CONTAMINATION ASSESSMENT REPORT ADDENDUM SITE 3054 NAS WHITING FIELD FL
10/1/1993
ABB ENVIRONMENTAL

CONTAMINATION ASSESSMENT REPORT ADDENDUM

**SITE 3054
NAVAL AIR STATION WHITING FIELD
MILTON, FLORIDA**

**Response to FDER Comments
Site 3054
Naval Air Station Whiting Field
Milton, Florida
Contract No. N62467-89-D-0317, CTO No. 009.**

**FIGURE 2-1
 MONITORING WELL LOCATIONS**

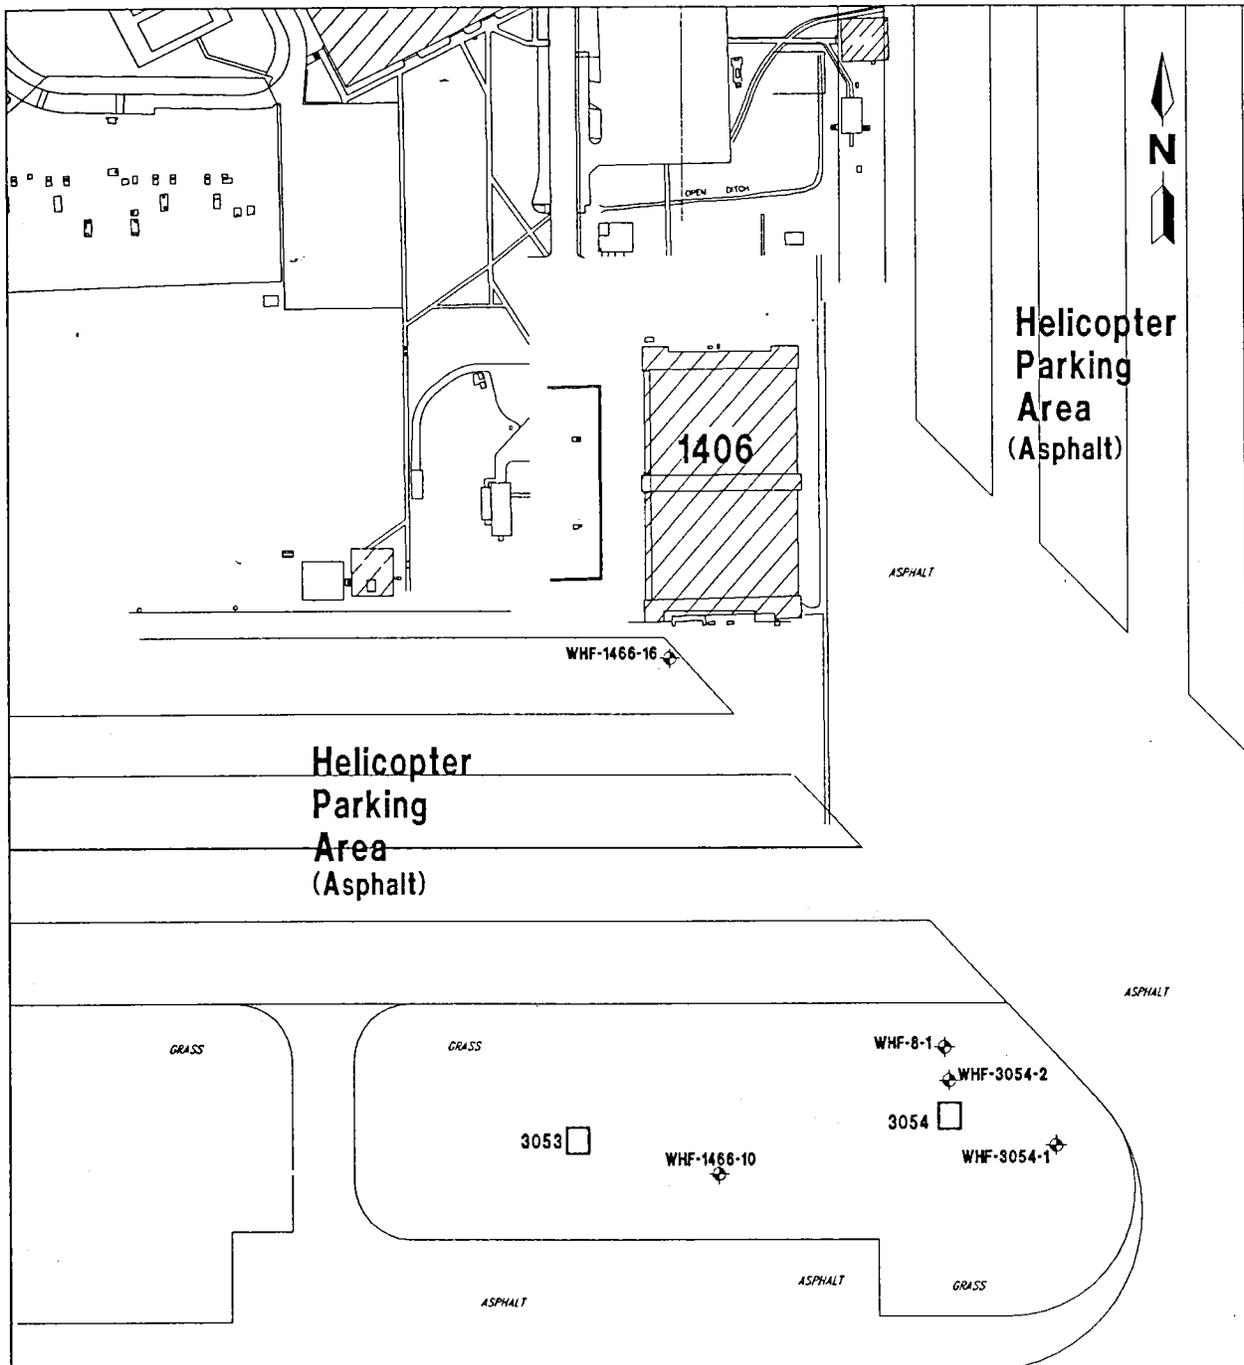
- a. One water table well in the immediate vicinity of monitor well WHF8-1. This well should be designed to sample the uppermost portion of the aquifer and have a screened interval overlapping the water table. Note, the screened interval of this well should be at least two feet above the mean annual high water table and include at least five, but not more than fifteen feet of the saturated zone."

ABB-ES and the Navy do not agree that it is necessary to install one additional monitoring well in the immediate vicinity of monitoring well WHF-8-1 to define the possible extent of groundwater contamination at Site 3054. One monitoring well, WHF-3054-1, was installed at the site in a location where historical data indicated the released AVGAS fuel had accumulated. Laboratory analytical results of groundwater samples from well WHF-3054-1 indicated that all Kerosene group compounds were below method detection limits. Results of OVA headspace analysis of soil samples from borings drilled at the site were far below FDER May 1992, "Guidelines for the Assessment and Remediation of Petroleum Contaminated Soils" and OVA readings of soil samples collected at the water table ranged from 0 to 2 ppm (the highest OVA soil headspace reading was 14 ppm at 5 feet below land surface in the boring, SB-3, nearest well WHF-3054-1).

Existing monitoring wells WHF-1466-10 and WHF-1466-16 (installed for site 1466 after submittal of this CAR) are located in the immediate vicinity of the site and provide adequate spatial coverage of the area affected by the AVGAS release to assess the extent of groundwater contamination. ABB-ES recommends that groundwater samples be collected from these wells to augment the existing groundwater and soil analytical data. The installation of an additional monitoring well screened in the upper water bearing zone in the immediate vicinity of existing well WHF-8-1, is not recommended.
